Subject: MHI's Response to US-APWR DCD RAI No. 809-5957 Revision 3 (SRP 15.0)

MHI's Response to US-APWR DCD RAI No. 809-5957 Revision 3

RAI NO.:NO. 809-5957 REVISION 3SRP SECTION:15 - INTRODUCTION - TRANSIENT AND ACCIDENT ANALYSESAPPLICATION SECTION:15.0DATE OF RAI ISSUE:8/22/2011

QUESTION NO.: 15-33

Figure 15.2.1-1

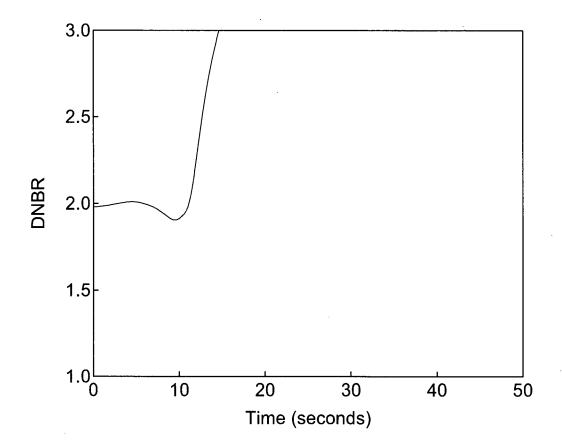
Figure 15.2.1-1 demonstrates that the minimum DNBR remains above the 95/95 limit and no fuel failures are predicted.

It should be noted that the base analysis for the loss of external load-and turbine trip is to |^{DCD_15-33} evaluate peak RCS and main steam system pressures, and is presented as part of the barrier performance analysis in Section 15.2.1.4. Therefore, only the DNBR versus time parameter plot is provided for the core response analysis. The responses of the other parameters shown in Figures 15.2.1-2 through 15.2.1-7 are approximately the same for this case.
